**Calvert Cliffs
Nuclear Power Plant**

SUBJECT: Calvert Cliffs Nuclear Power Plant
Unit Nos. 1 & 2; Docket Nos. 50-317 & 50-318
Response to NRC Request for Additional Information Regarding ASME Code
Relief Request to Authorize Use of Mechanical Nozzle Seal Assemblies at
Calvert Cliffs Nuclear Power Plant as an Alternate Repair Method

**RESPONSE TO REQUEST FOR ADDITIONAL INFORMATION
MECHANICAL NOZZLE SEAL ASSEMBLY**

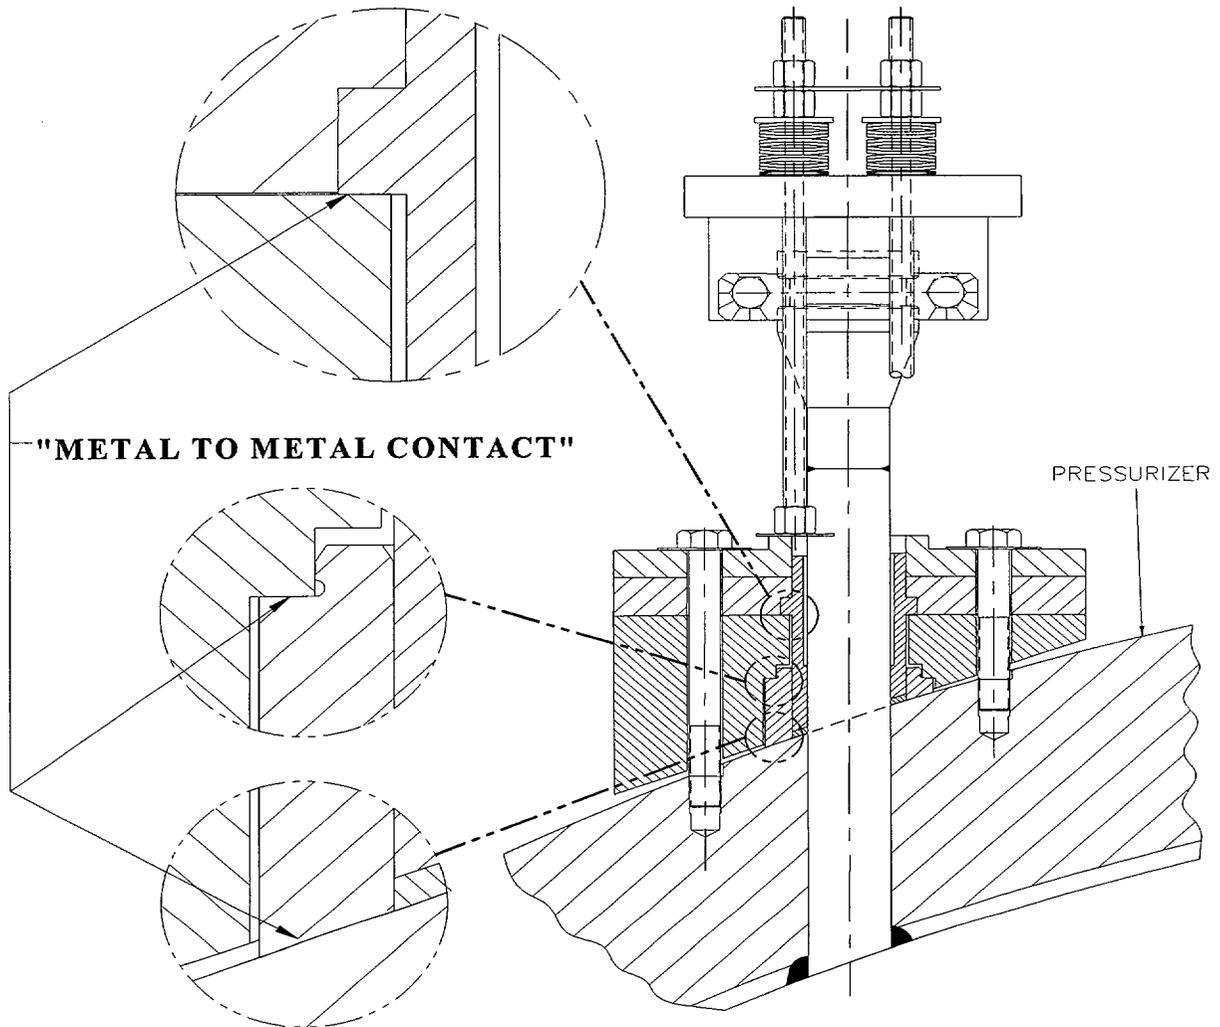
Reference (2) states that additional thermal test cycles are not considered necessary since the MNSA components are designed to go "metal-to-metal," confining the graphite seal in a fixed volume, and that thermal cycling does not "work" the seal; and, therefore, the MNSA design is not sensitive to thermal cycling effects.

- a. Provide a description, including a diagram, of what is meant by "metal-to-metal."
- b. Provide test data or analysis to support the assertion that "thermal cycling does not work the seal" by showing that the graphite seal experiences zero thermal expansion or contraction under varying thermal conditions.

- a. A detailed schematic of the area of concern is provided below.

- b. The Grafoil seal is captured in a small volume that will not vary except microscopically. The bolt preload maintains the pressure and captures the seal to a nearly constant volume. Similar seals are being used in a variety of applications (valve stem seals) under significantly more thermal volume changes. Grafoil, therefore, can be considered to be a relatively stable seal material, especially when the volume changes are minor. Assuming an annular section of 1/4" (width) x 1/4" (height) x 1.1" (diameter), the volume is computed as $1/4 \times 1/4 \times 3.14 \times 1.1 = 0.215875$ [in³]. Then, assuming an expansion coefficient of $6E-6$ [in/in-Deg], and a temperature differential of 500°F, each dimension changes as follows:

0.250" expands to 0.25075" and
1.100" expands to 1.1033".

The total volume of the Grafoil seal is then 0.2178237 [in³], which equals a percentage change of $(0.2178237-0.215875)/0.215875 \times 100 = 0.9$ [%]. Thus, even neglecting the thermal

expansion of the Grafoil seal, the total volume is well within the initial compression of the Grafoil seal (approximately 35%).
